SUBJECT: SUBMITS ANALYSIS SUPPORTING AMEND TO APP A OF OL DPR-31 &
 DPR-41, DETERMINES DNBR SAFETY LIMIT OF 1.24 CONSISTENT
 W/COBRA IIIC COMPUTER CODE, FORWARDS "DNBR SAFETY LIMIT FOR
 COBRA III C ANALYSIS."

Re: Turkey Point Units 3 & 4
Docket Nos. 50-250 and 50-251
Proposed Amendment to Facility
Operating Licenses DPR-31 and DPR-41

Figure 2.1-1 Reactor Core Thermal and Hydraulic Safety Limits, 3 Loop Operation

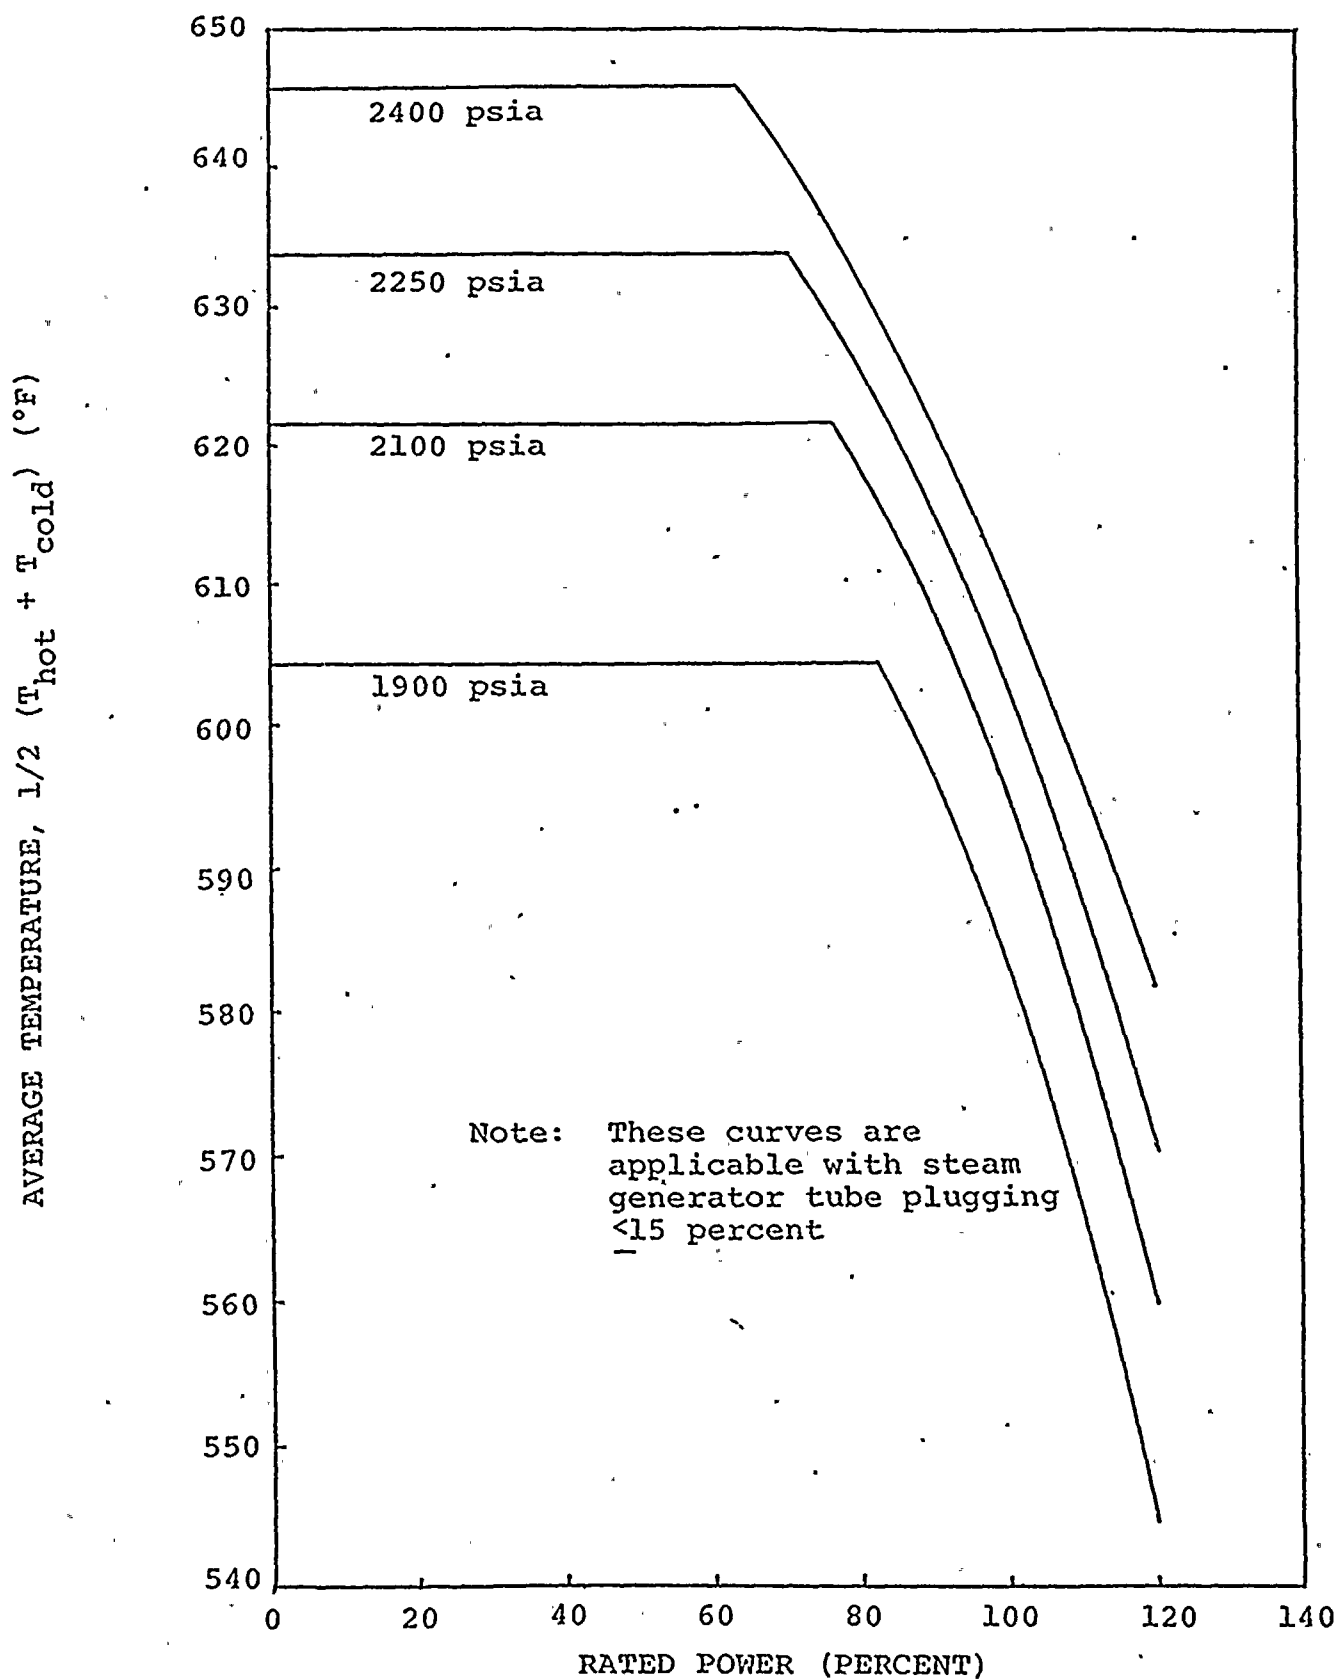
The information supplied herewith supplements our previous submittals concerning the effects of rod bow on DNBR at Turkey Point Units 3 and 4. It is proposed that the attached Reactor Core Safety Limits be substituted for the present Figures 2.1-1, 2.1-1a and 2.1-1b in the Technical Specifications, and that with these new and more restrictive limits, the units can be operated safely without any other penalties for rod bow.

The curves in the Specification represent the loci of points of thermal power, coolant system pressure and average temperature for which the DNBR is no less than 1.273. The area of safe operation is below these lines.
